SAN FRANCISCO PLANNING DEPARTMENT

Discretionary Review Abbreviated Analysis HEARING DATE: JANUARY 16, 2020

Date: December 30, 2019
Case No.: **2019-005400DRP-02**
Project Address: **166 Parker Avenue**
Permit Application: 2019.0410.7564
Zoning: RH-2 [Residential House, Two-Family]
40-X Height and Bulk District
Block/Lot: 1065 / 032
Project Sponsor: Jonathan Pearlman
Elevation Architects
1159 Green Street #4
San Francisco, CA 94109
Staff Contact: David Winslow – (415) 575-9159
David.Winslow@sfgov.org
Recommendation: **Do Not Take DR and Approve**

1st & 2nd Floor Plans

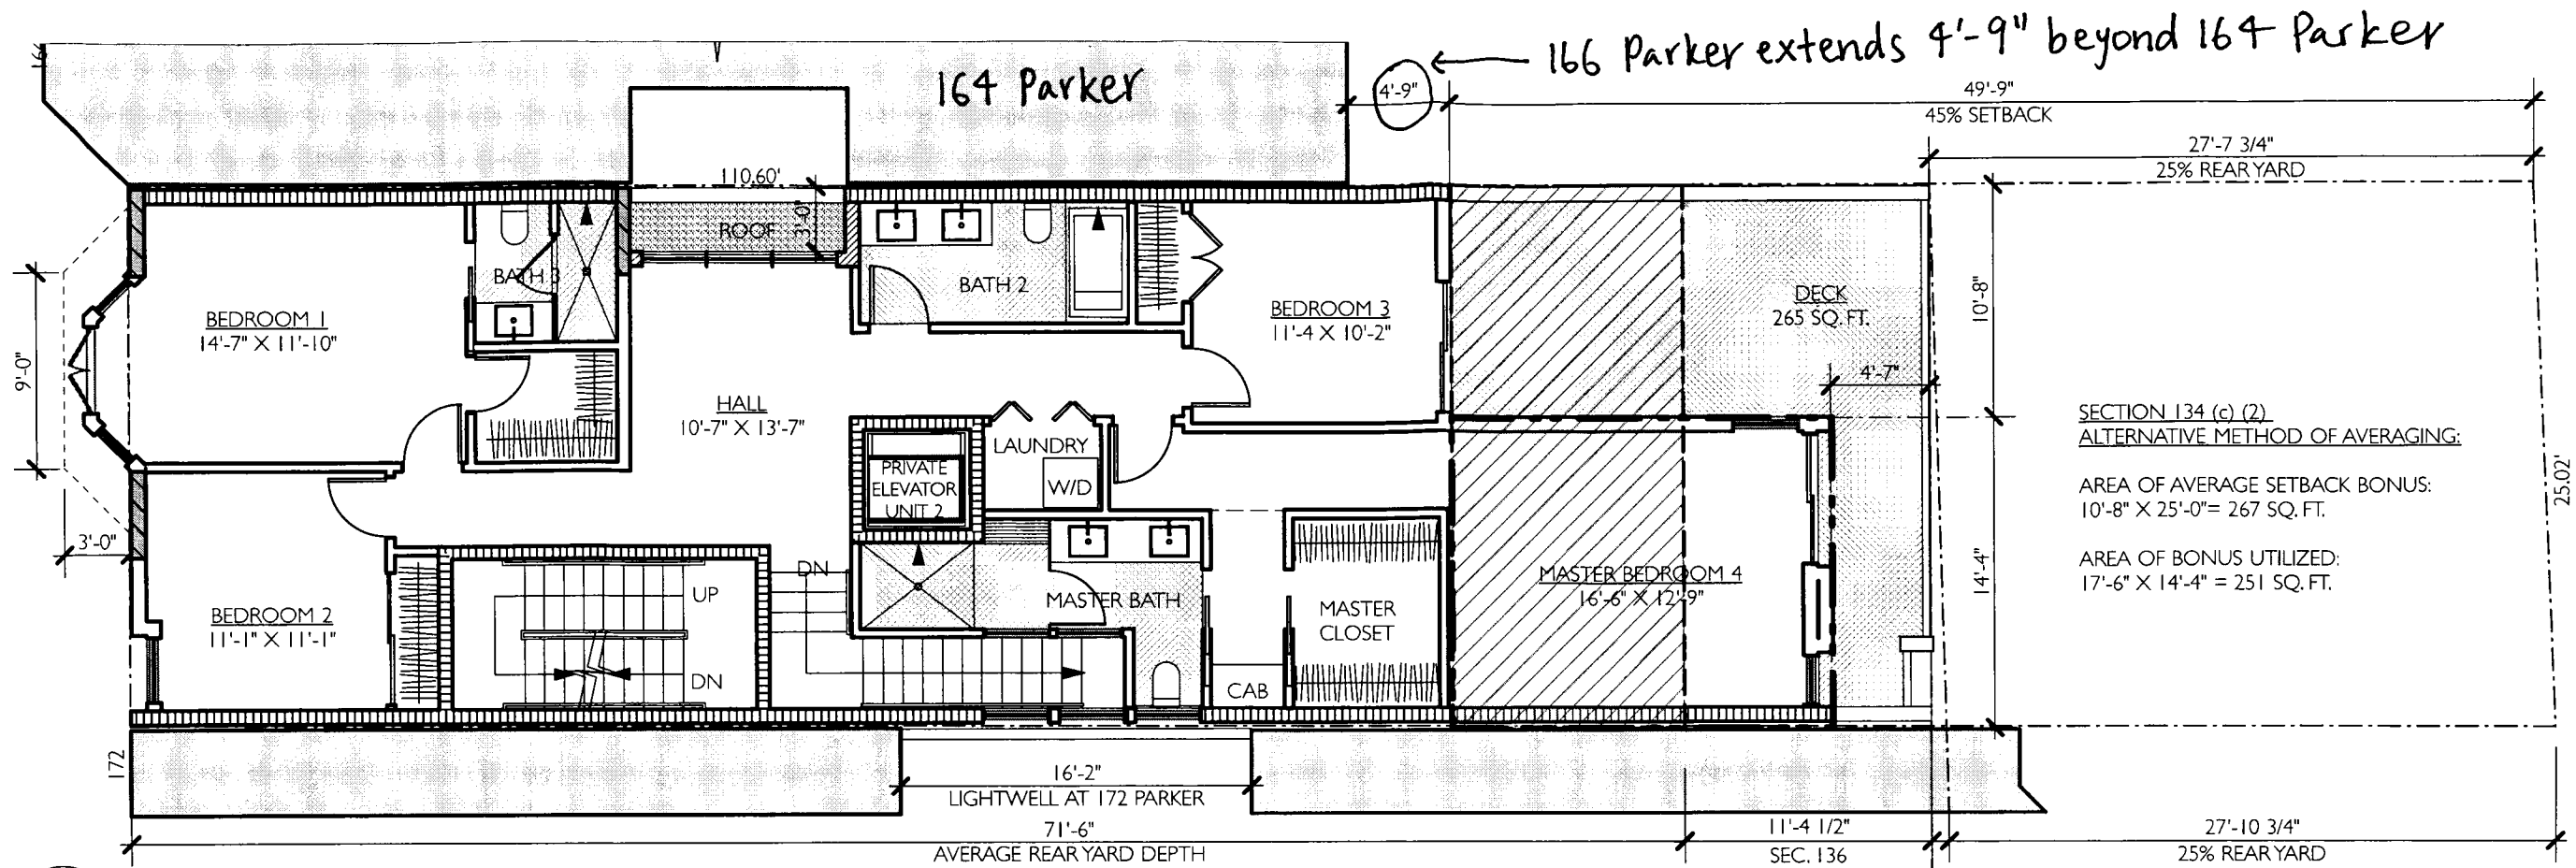
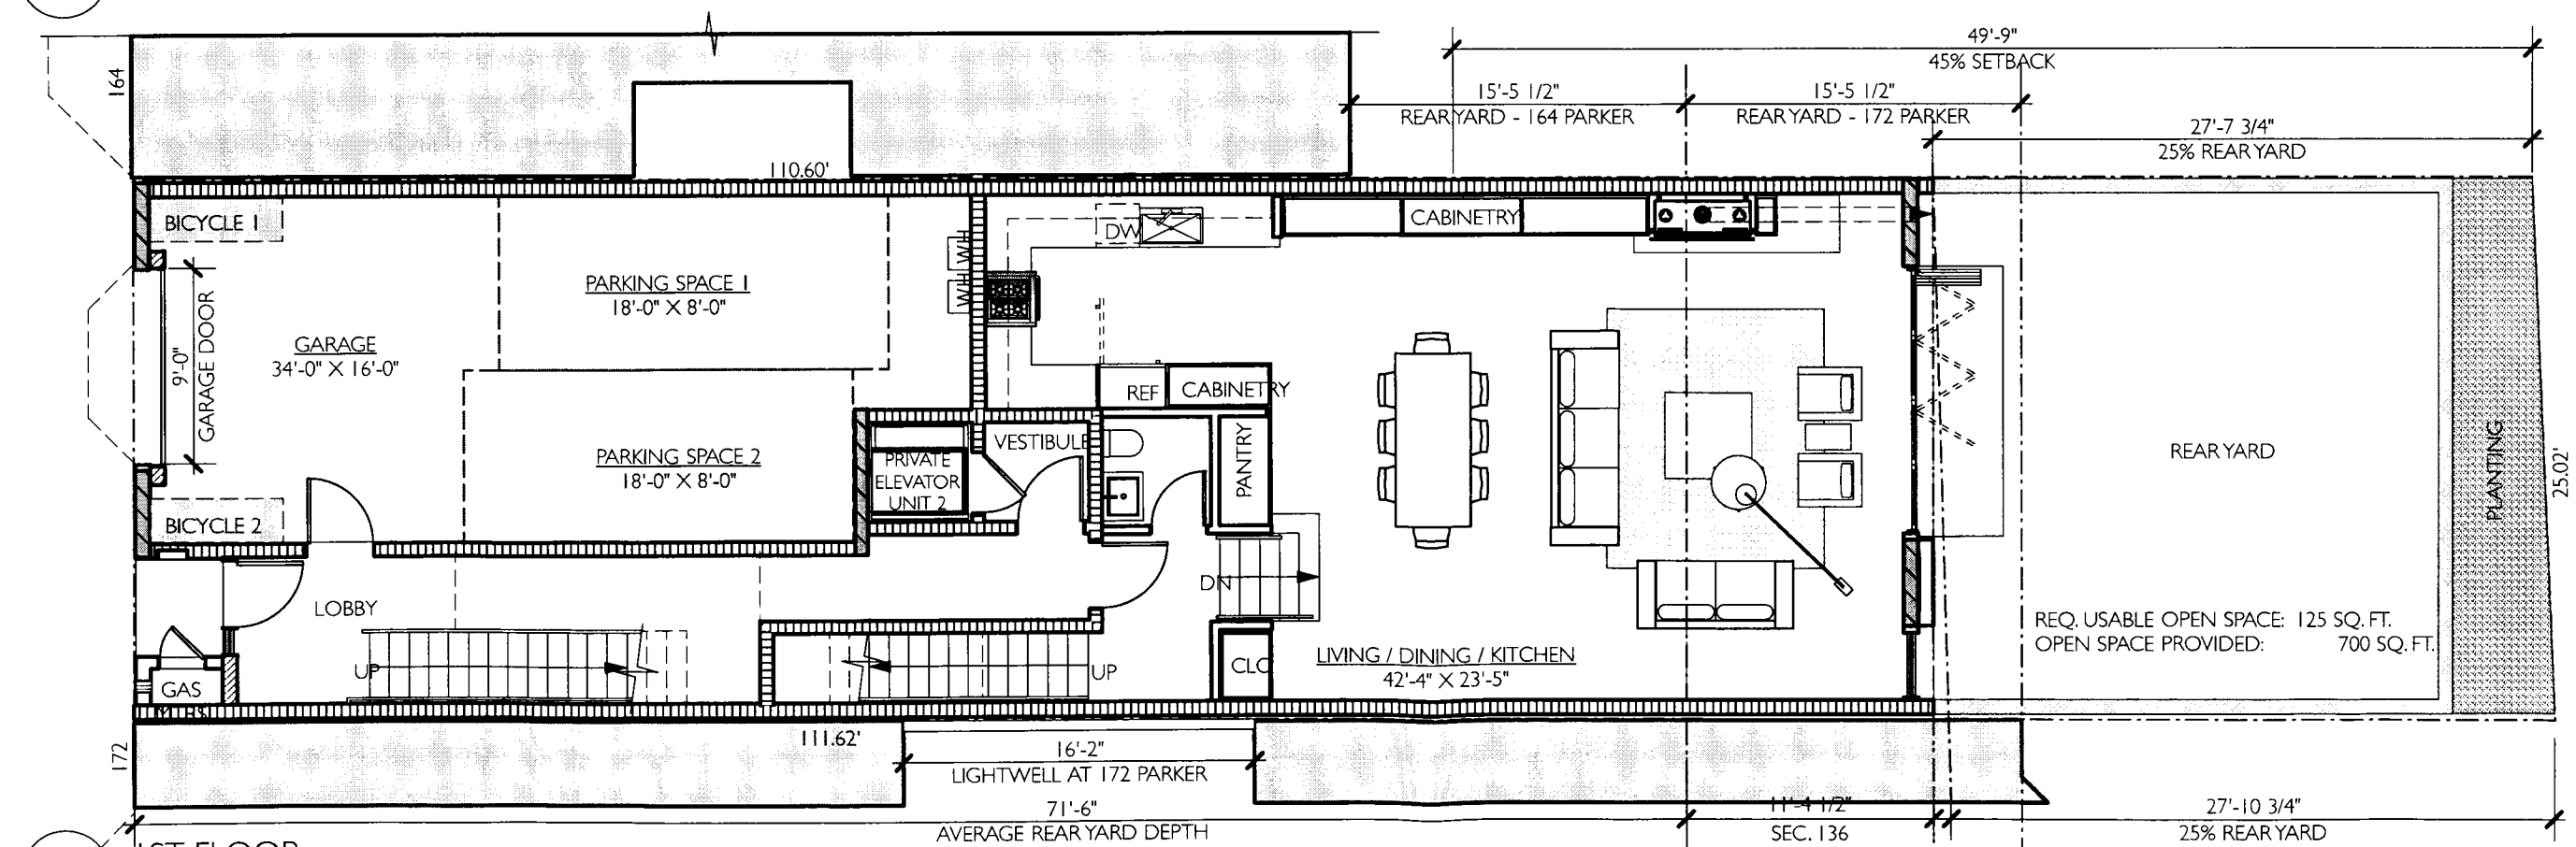
The current 166 Parker proposed plan of the rear at the north (adjacent to 164 Parker) extends 4'-9" beyond the depth of 164 Parker Ave. 164 Parker is proposing the 166 Parker north building wall be flush with the 164 Parker from Levels 2 to 4.

164 Parker spoke to Christopher May at planning on 26 September 2019, who stated the area lost due to the aligning 164 and 166 Parker rear walls is recoverable. Therefore, 164 Parker is requesting further review into the rear yard massing of 166 Parker. 164 Parker continue to propose the 166 Parker align their north wall with 164 Parker. We also believe this proposal would be inline with the intent of the comment from SF Planning from July 2019.

West Elevation

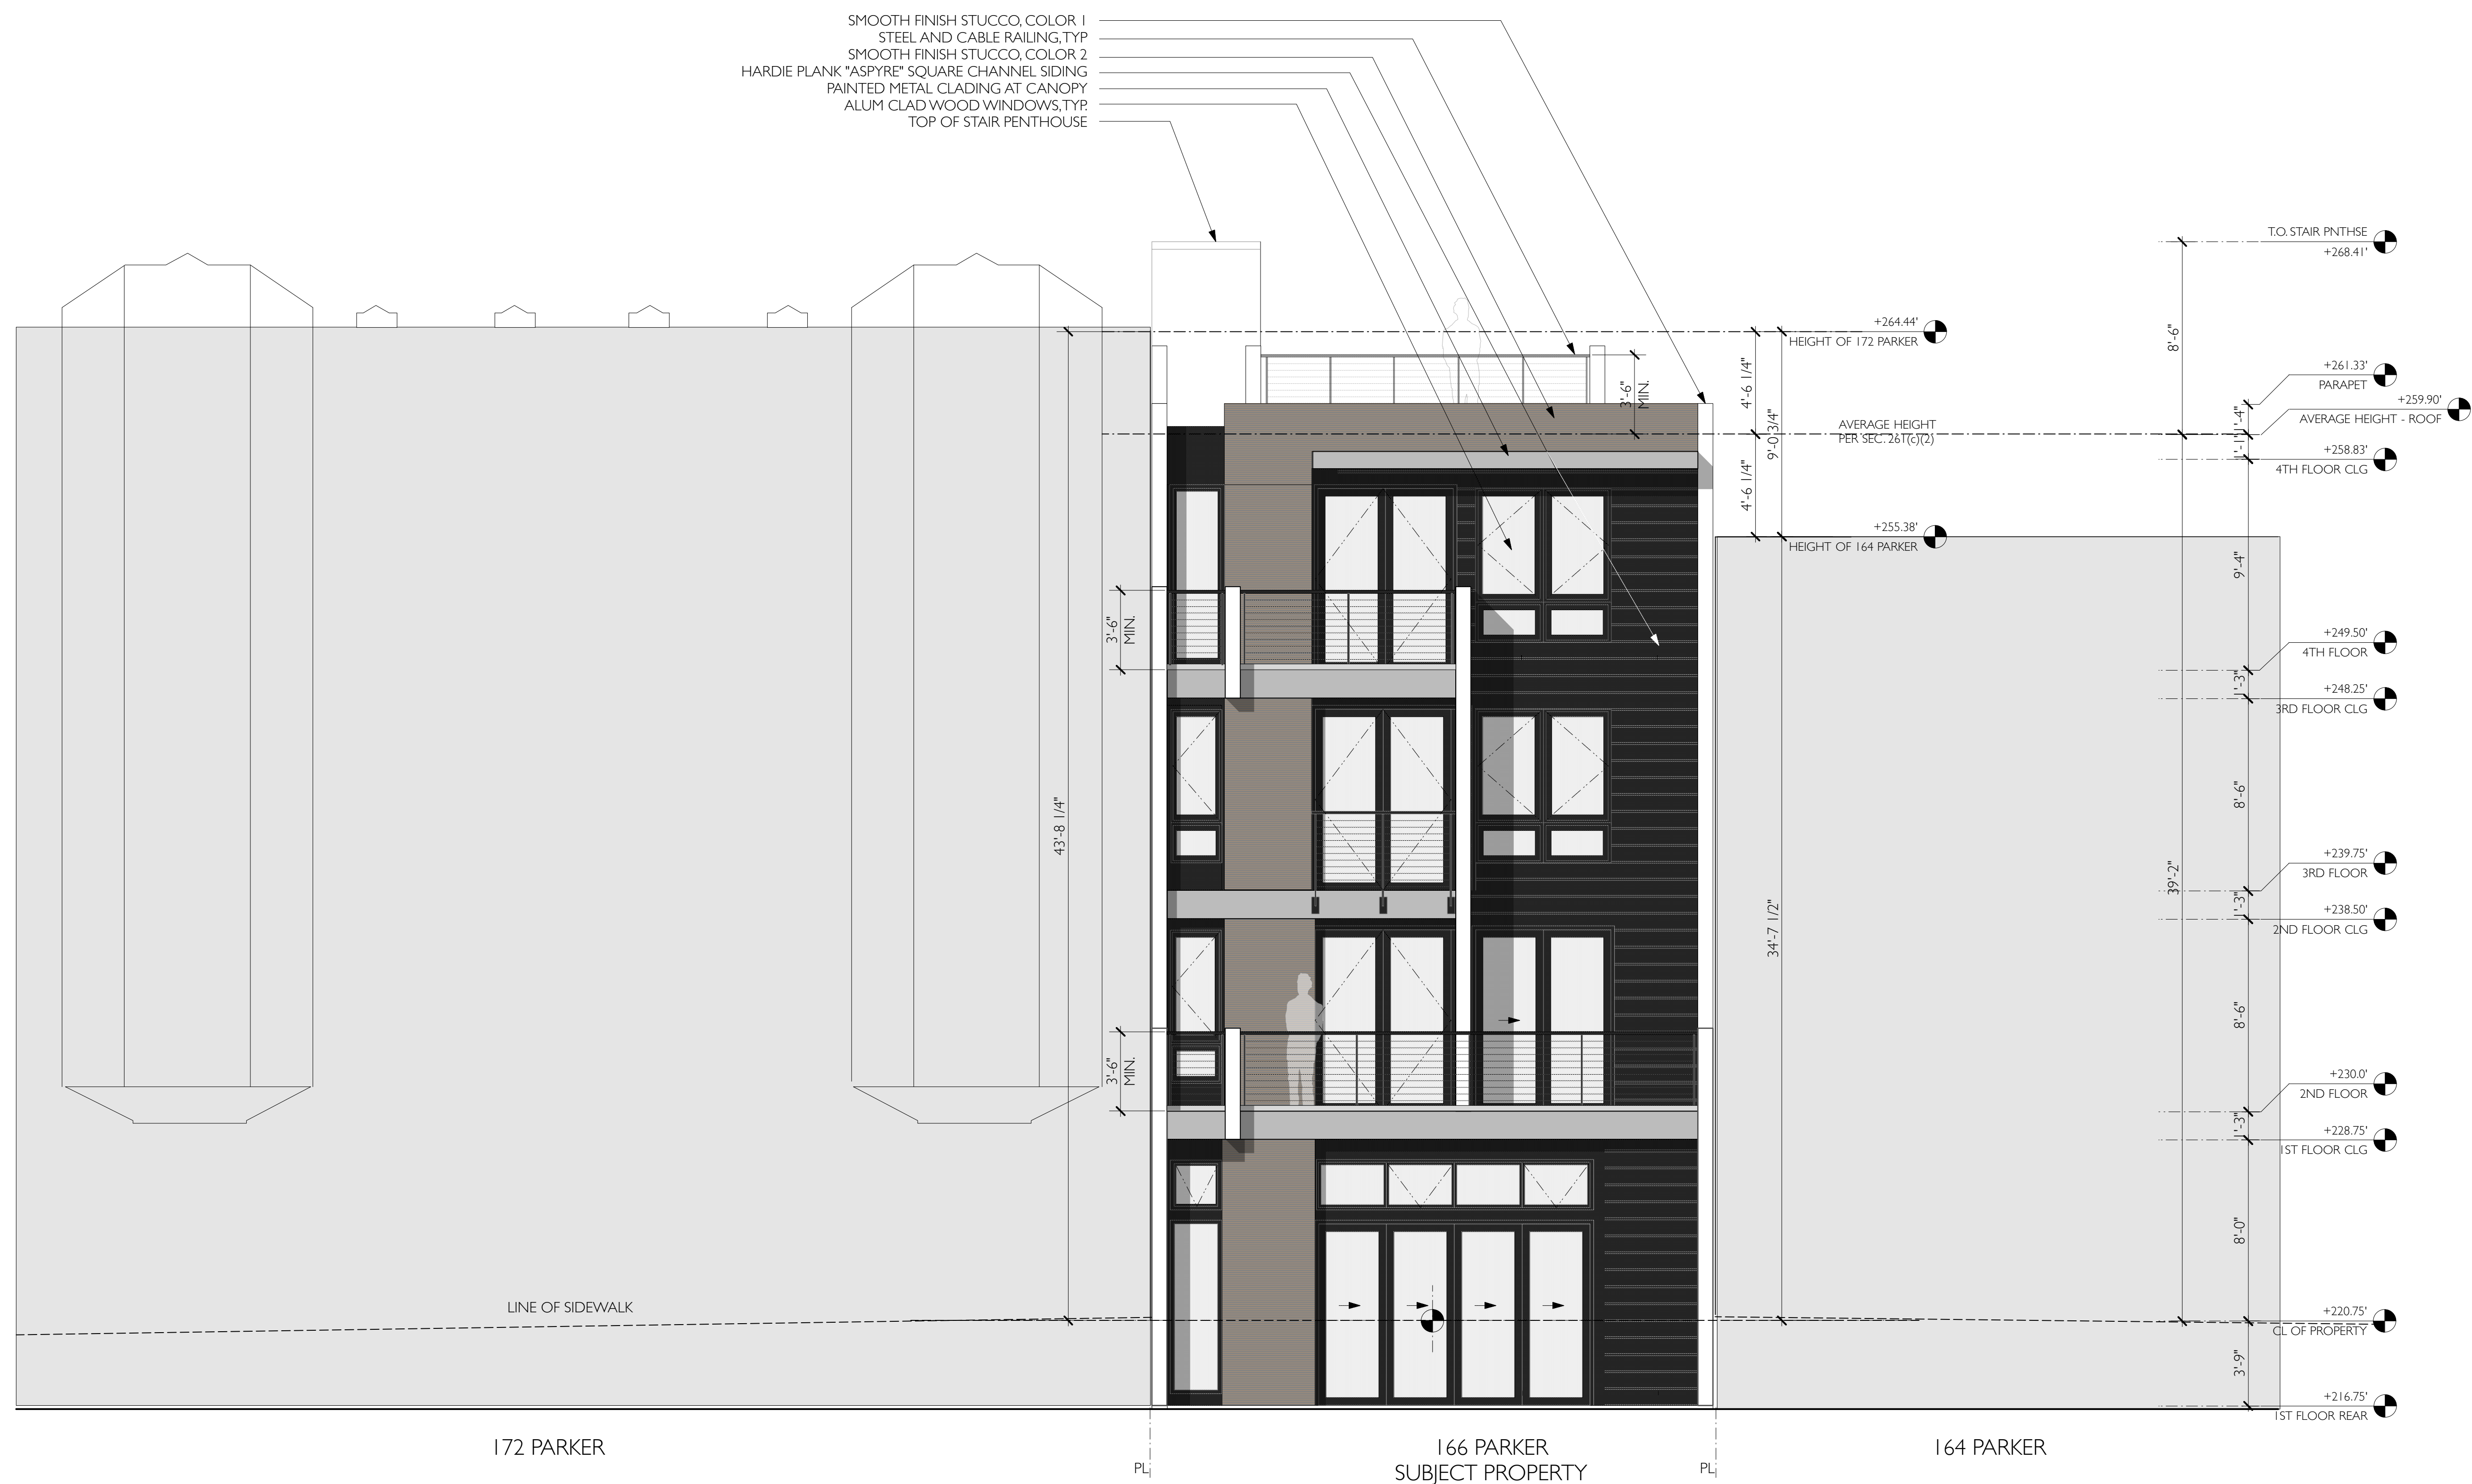
Move the top 4th floor level back as it is non-detailed with a flat commercial look and has no relation to the rest of the buildings on the block and should be reduced in height from 9'-4" to 8'-6" 10 feet or 45-degrees to the front wall plane, whichever is greater, as the 2-unit buildings give deference at the street to the 3-story buildings of the block without resorting to creating a 40-foot front wall plane that cuts the sky edge with its squared-off look. The resulting wall would extend 172 Parker's front wall which is already triple-wide at 75 feet to 100 feet with 166 Parker. There is a rhythm to this block rather than one expanse of wall.

The top floor at 9'-4" (with 1'-1" inter-floor height = 10'-5") breaks the height and symmetry of the other lower levels above street level of 8'-6" and adjacent buildings for the living floors reflects floor symmetry for heights. The top floor is like the bottom floor of a commercial building downtown with the added height and the flat commercial lines. The measurements (elevation numbers) need to be looked at. The proposed building top floor (4th floor) is 9'-4" + 1'-1" = 10'-5". The average building height between 164 Parker (35'-6" tall) & 172 Parker (43'-8 1/4") is 39' 7-1/8" but no building in RH-2/40-X should be above 40 feet high. Using a building that was pre-zoning code and pre-RDG should be disregarded & the 172 Parker building should be considered at 40'. That will reduce the height of 166 Parker which attempts to get to the absolute maximum of allowable under Planning Code with no real need to do so. The total measurement at the front with the parapet equals 40'-14" (4'-6 1/4" + 35'-6"). As pedestrians from the street look at this 2-unit building, it will appear overly tall compared to other 2-unit buildings. The non-descript trim and parapet features only seek to maximize and go over the 40 ft. height limit.

For design, the architectural white trim feature that runs from the street level to the roofline originally positioned toward the middle of the front façade moved completely to the right side (south) and is taller than the roofline so that it sticks up like a finger. This feature does not add or accentuate the

The top 4th floor plain modern characterless windows are overly tall to over-emphasize the verticality of the building which including all features is over 40 feet tall. The windows on the entire building but most especially on the right (south) side, appear upside down with the small panes at the bottom of overly tall upper sections as compared to adjacent Edwardian and Art Deco buildings and those across the street. These are the same style windows found on commercial buildings. Window sizes are longer due to the bottom panes which do not add to reinforcing the existing older designs on the buildings adjacent or across the street. Shorten, make more smooth transition from adjacent window sizes and those across street and remove the bottom panes.

The floor-to-floor height of 9'-4" (without inter-floor additional heights included) for the top 4th level floor is not only not consistent with Floors 2 and 3 but also makes the building look top-heavy. It appears to have been put there as a means to introduce the Urban Design Guidelines (UDG)-like element and is an inappropriate articulation that would bleed into the rest of the block. The UDG on Page A5 states, "Use full top floor to articulate the top of a building façade." (See UDG pictures pages.) The articulation should be that of the lower levels with the bay and add more details to give deference to the existing character of the other buildings on this block.

DR 2: Since this DR request calls for the complete redesign of the building based on the DR requester's own interpretation of the Planning code and the Residential Design Guidelines, we are not willing to make any physical changes to the design. The proposed design in form, massing, materials and features are consistent with the Residential Design Guidelines and are a compliment to the myriad of styles, scale, forms and materials that can be found in the 100 block of Parker Avenue and therefore, will have no adverse effect on the surrounding properties. As there are no extraordinary or exceptional circumstances cited in the DR application, we are unwilling to modify the project at all, except as noted in the response to question 2.
